Application for Appeal**Planning and Building Division**

Permit Numbers involved: Coastside Design Review,
 File No. PLN 2005-00607

ATTACHMENT 3 BASIS FOR APPEAL

RE: Steve Peterson, Proposed Residence
_____ Miramar Drive, Half Moon Bay

SITE PLAN - COMMENTS

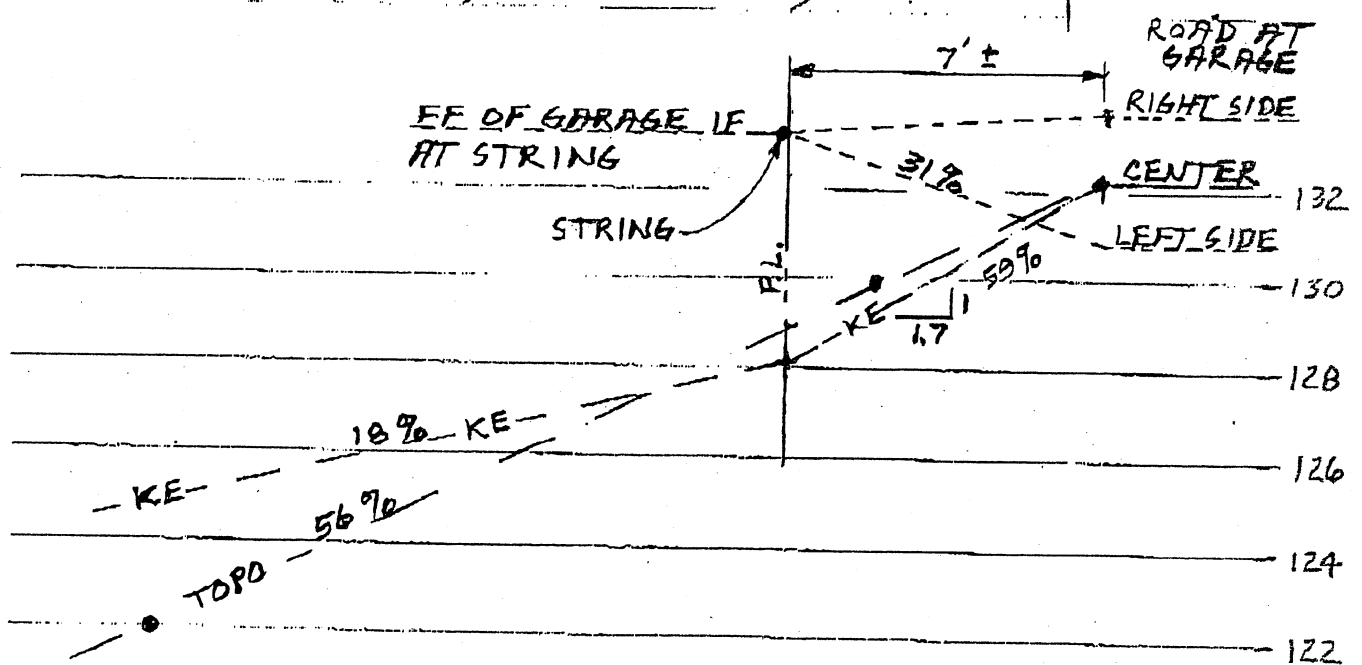
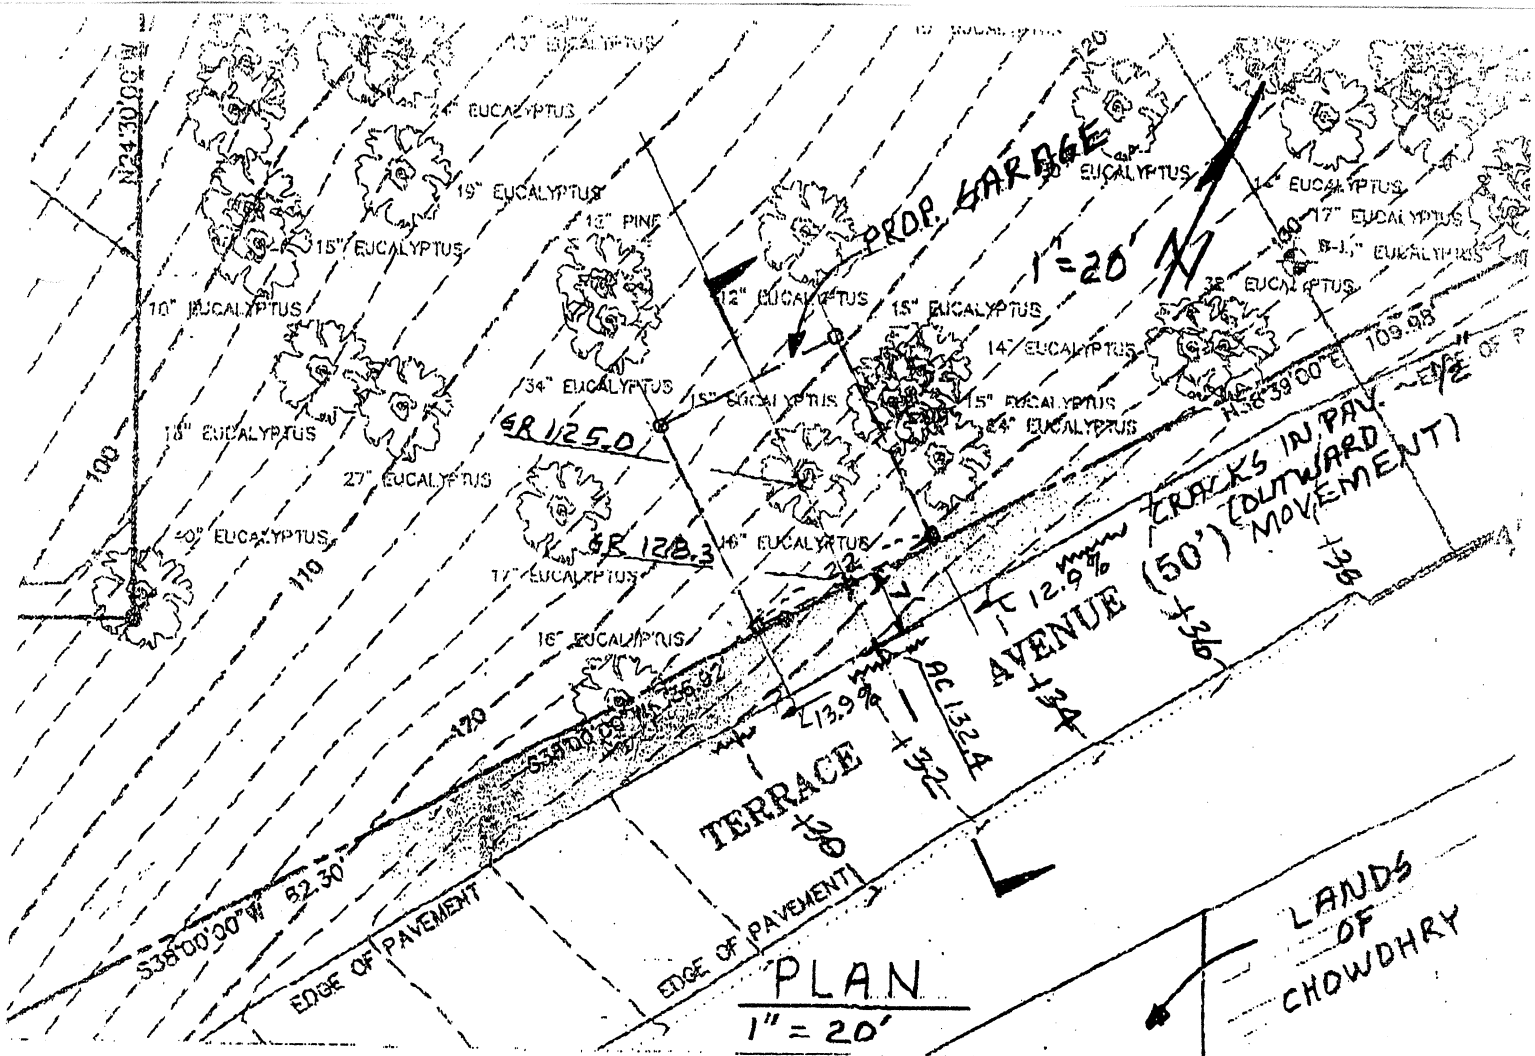
SK-1 SITE PLAN - COMMENTS. This is based on the above Sht. A-0.6.

3. **RELOCATE PROPOSED GARAGE TO MIRAMAR DRIVE.** In my opinion this would provide a more direct access to the site, put the garage closer to the existing ground and closer to the elevation of the house, reduce retaining wall construction, and reduce earthwork. This would also improve pedestrian access and emergency vehicle access to the house. Miramar Drive could be widened in the area of the lower access. The driveway would enter the site at about elevation 115 instead of going up to the corner, elevation about 142, and back down to about elevation 132 for the upper location. A pedestrian access could still be provided off of Terrace Ave.

GARAGE - COMMENTS

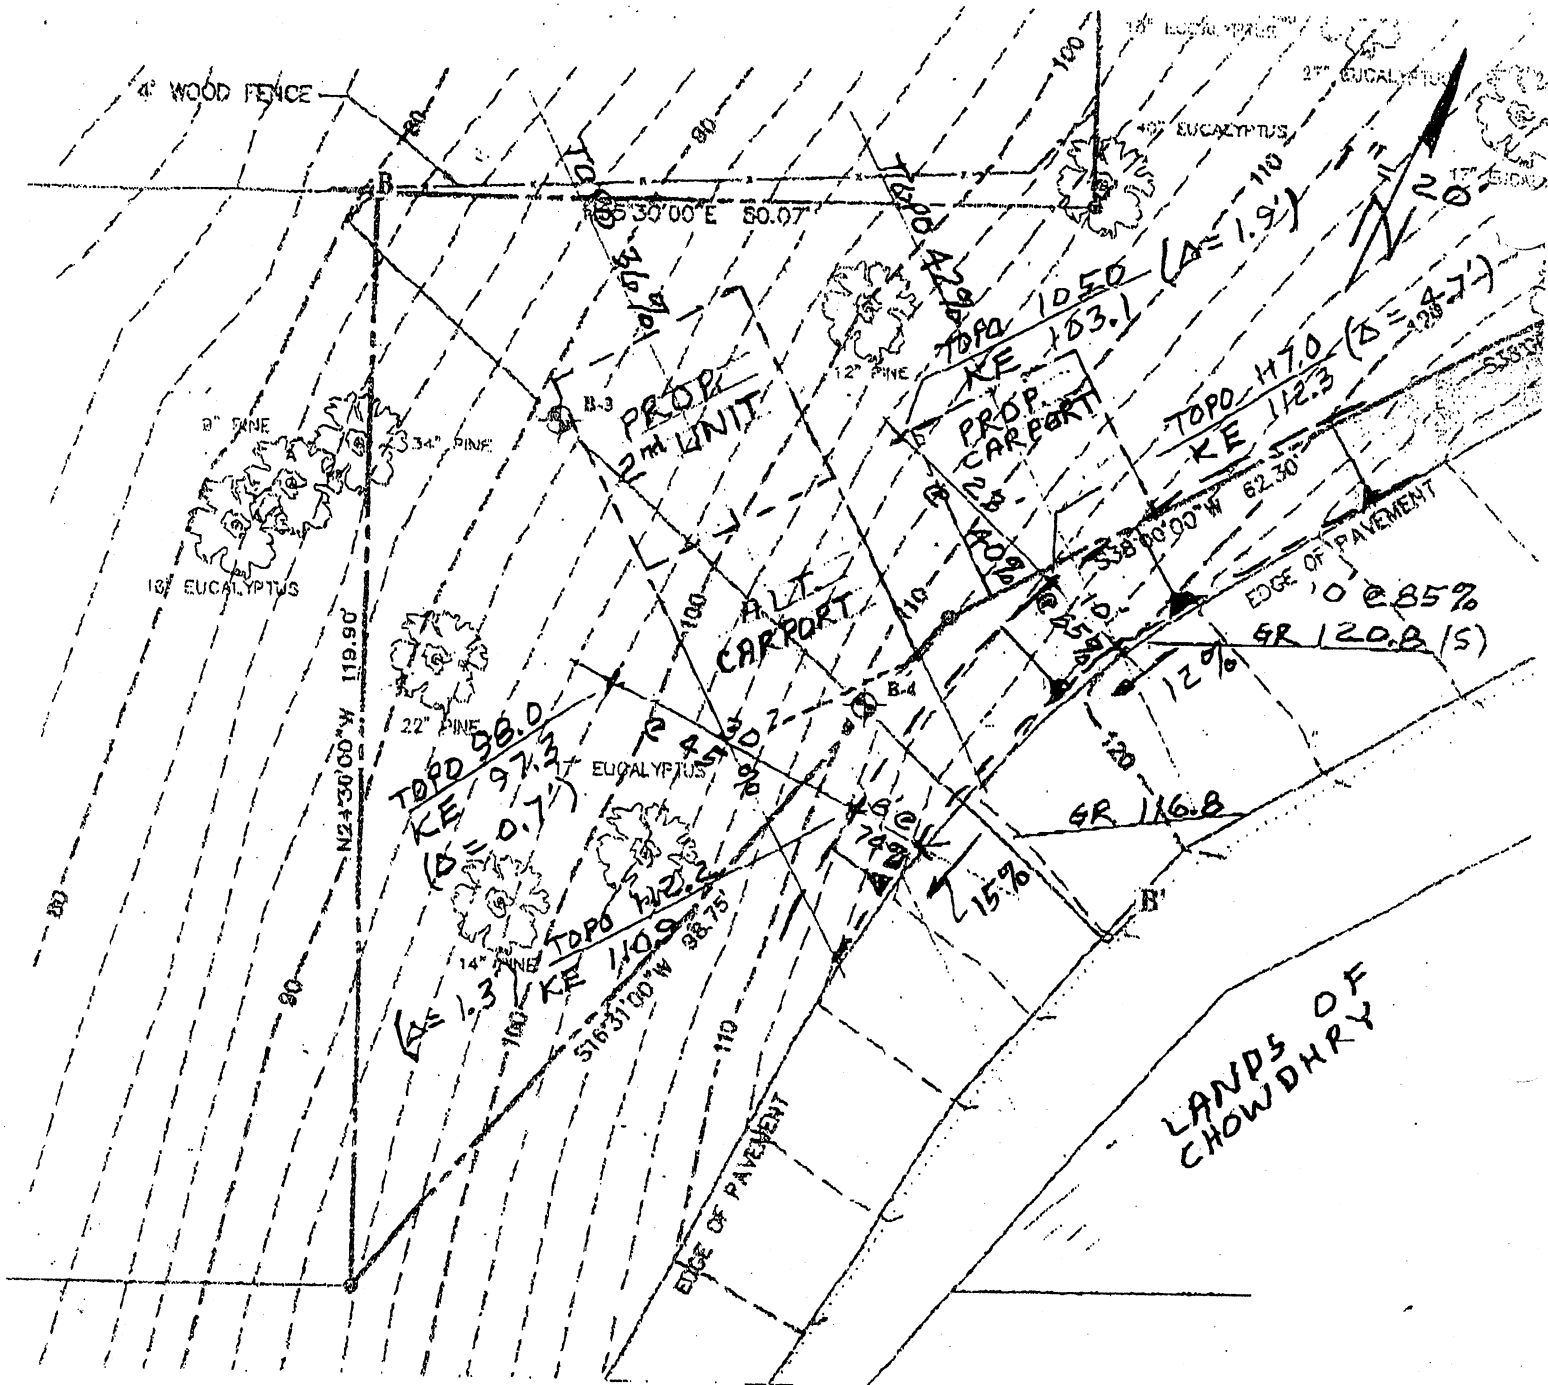
1. **LOCATION AND ELEVATION OF GARAGE STORY POLES.** I found a steel stake which indicated an angle point in the property line. It was about 7 feet from the edge of the pavement of Terrace Ave. which is what is scaled from SK-2. The left edge of the garage story pole was a little to the west of this steel stake and about on the property line. The next story pole to the right was about 22 feet away which is about the proper distance scaling from SK-1. SK-1 does not show the finish floor elevation of the garage. There was a string on a level line across the front of the garage which seemed to represent the finish floor of the garage, however, at the left side of the garage the string was about 2.2 feet above the adjacent pavement of Terrace Ave., and at the right side of the garage it was about 0.5 feet below the adjacent pavement of Terrace Ave. At the west side of the garage, this would be a slope of about $2.2/7$ or 31% slope, more than the maximum slope for a driveway, 20%. In my opinion, if this string was to represent the finish floor, it was about 1 foot too high.

2. **TOPO AT PROPOSED GARAGE.** SK-2 shows the results of my preliminary measurements. From the northerly edge of Terrace Ave. the ground slopes down relatively steeply to the property line. I measured this slope at 4.1' drop in 7.0 horizontal, or about 0.59%, or 1.7 horiz. to 1 vert. This is clearly a fill slope ending about at the property line. From the property line, the slope continues down at a slope of about 2.5' in 14' or 18%. The project topo shows a uniform slope of about 56%. Using my Smart Level, I measured a longitudinal slope on Terrace Ave. in front of the garage as follows: opposite west side 13.9%, opposite east side 12.0%. These slopes are consistent with the contour lines, 4' drop in 32', or 12.5%. This longitudinal slope makes a difficult transition to a garage (flat) only 7 feet away. The edge of the pavement had cracks about 1/2" wide indicating outward movement and should be addressed by the geotechnical engineer.

CARPORT - COMMENTS SK-3

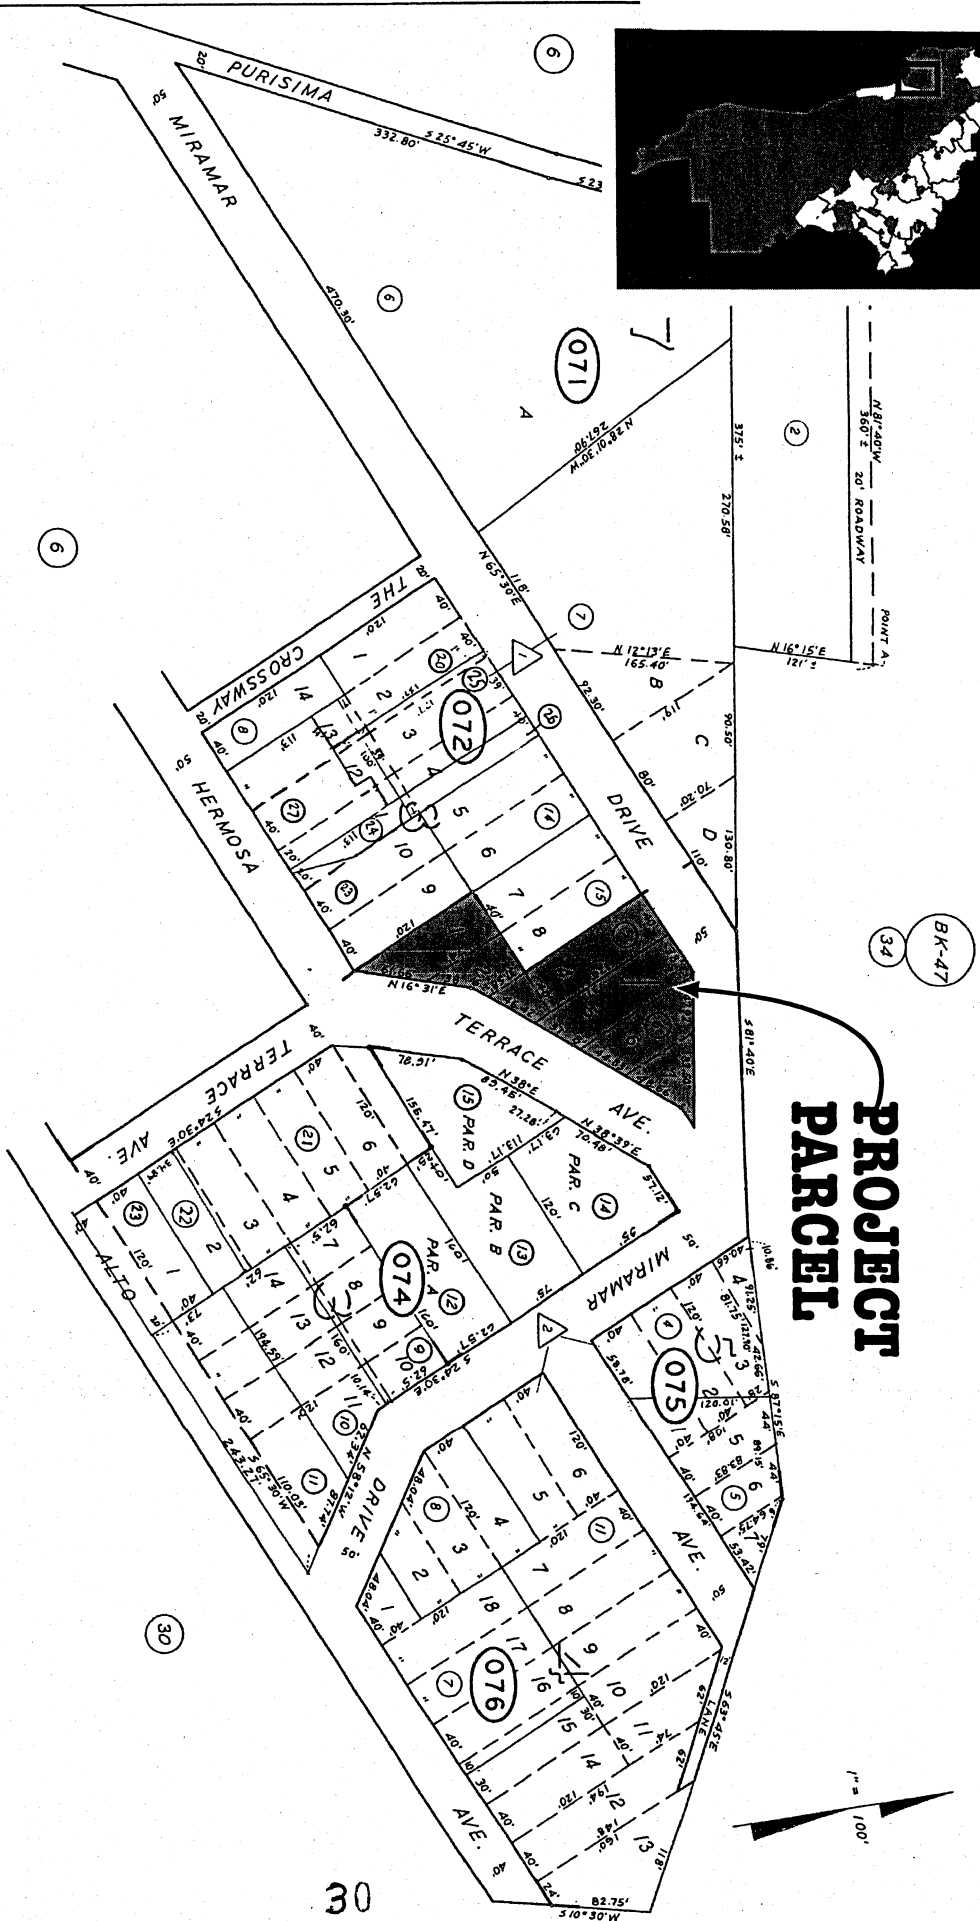
4. **TOPO AT PROPOSED CARPORT.** SK-3 shows there is a steep bank (85% slope) for about 10 feet right off of the road, making 4.7 feet of difference in the contours (topo is too high) at the front of the garage. The average slope per the topo is about 42%. The carport at this location would have the same problem of short transition from a roadway sloping at about 12%.

5. TOPO AT PROPOSED 2ND UNIT. SK-3 shows the slope off of the road at about 8' at a slope of 74%, making a difference of about 1.3' (again, topo too high). The average slope per the topo through the 2nd unit is 36%.
6. RELOCATE PROPOSED CARPORT TO IN FRONT OF 2nd UNIT. In my opinion this would put the carport in an area that is less steep off of the road, and would soften the impact of the carport by lowering it and moving it further from the road. The driveway would exit the road about 5 feet lower down the road and the carport could be an additional 4' lower because of the longer driveway (a total of 8 to 9 feet lower), placing it closer to the elevation of the 2nd unit. The rather extensive stairs would also be eliminated.

GRADING AND DRAINAGE PLAN

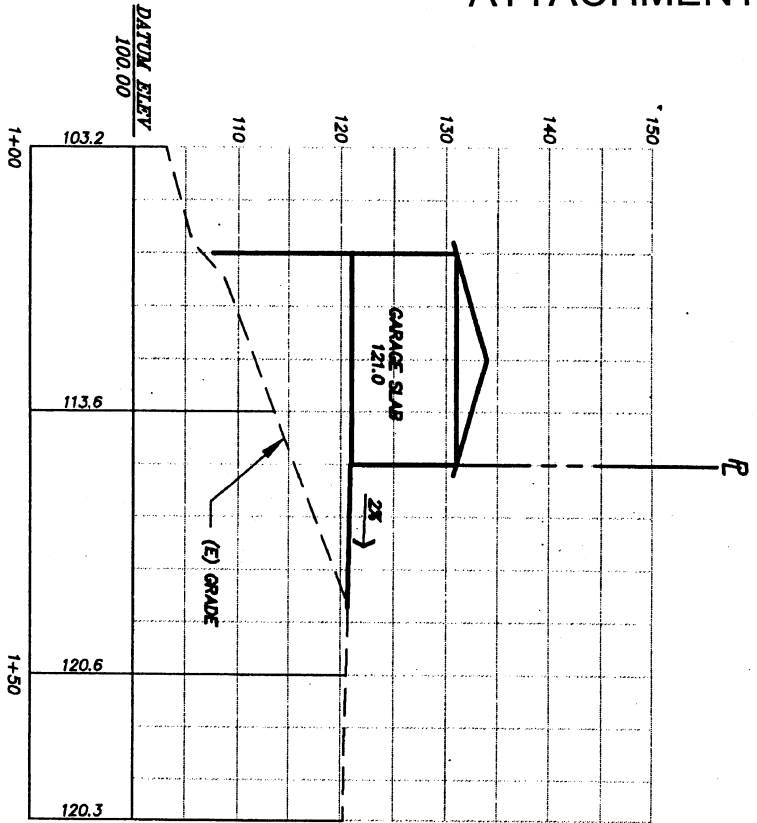
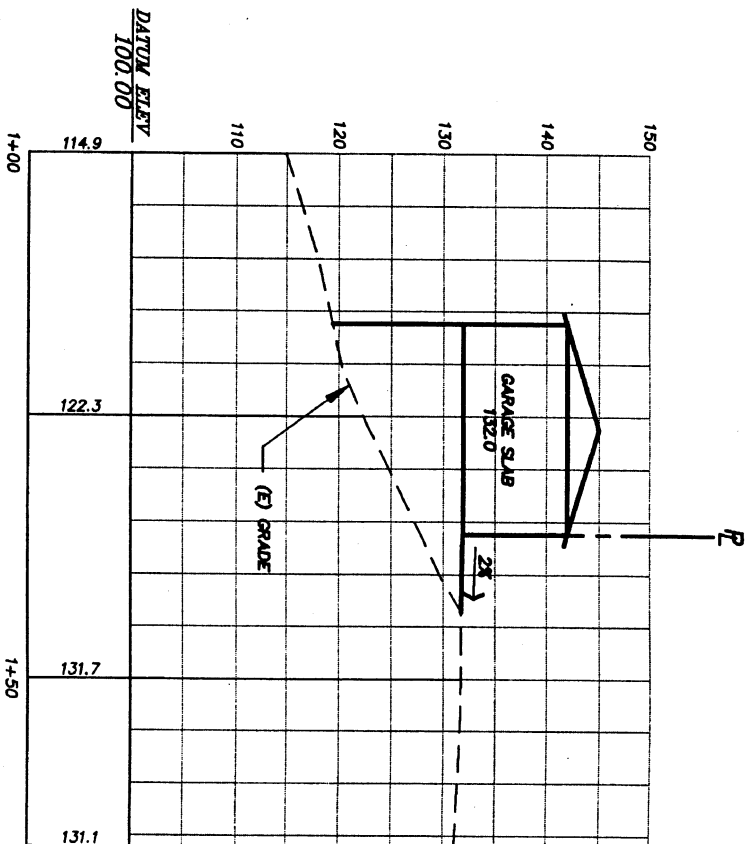
Appellant objects to the attached garage being located on Terrace Avenue and believe the garage should be located on Miramar Drive. The construction of the proposed driveway on Terrace Avenue will also considerably weaken the condition of Terrace Avenue and a retaining wall running the full length of Terrace Avenue will be necessary. (See Kavanaugh Engineering report, page 2, paragraph 3).

The proposed garage of the 3,500 square foot single-family residence and the carport of the detached second unit are both located on the property line with no setback. The grade to reach the garage and carport is severe. The drawing submitted by the owner is not accurate in this regard. (See Kavanaugh Engineering report, page 2, paragraphs 1 and 2). The driveway slope revealed by Mr. Kavanaugh's measurements is more than 30% when the maximum slope for a driveway should be no more than 20% (See Kavanaugh Engineering report, page 2, paragraph 1). Locating the garage off of Miramar Drive would allow a level entrance as well as lessen drainage and erosion issues.

Locating the garage on Miramar Drive would also reduce a dangerous or potentially dangerous condition. The garage, as currently planned, would require difficult access on the steep hill from Terrace Avenue to the proposed new residence. A proposed site plan with the proposed garage located on Miramar Drive is attached hereto as Exhibit "B". The currently approved plan requires that the driveway slope not exceed 20% and that driveways at the property line must be the same elevation as the center of the access roadway (See item number 17 of the Staff Report). The steep elevation existing at the access point from Terrace Avenue to the proposed new development creates a situation where it is unlikely that the slope will be both less than 20% with the driveway is at the same elevation as the center of the roadway (See Kavanaugh Engineering report, page 2, paragraph 1).

- 18. The applicant shall submit a driveway "plan and profile" to the Department of Public Works, showing the driveway access to the parcel (garage slab) complying with County standards for driveway slopes (not to exceed 20%) and to County standards for driveways (at the property line) being the same elevation as the center of the access roadway. When appropriate, this plan and profile shall be prepared from elevations and alignment shown on the roadway improvement plans. The driveway plan shall also include and show specific provisions and details for both the existing and the proposed drainage patterns and drainage facilities.
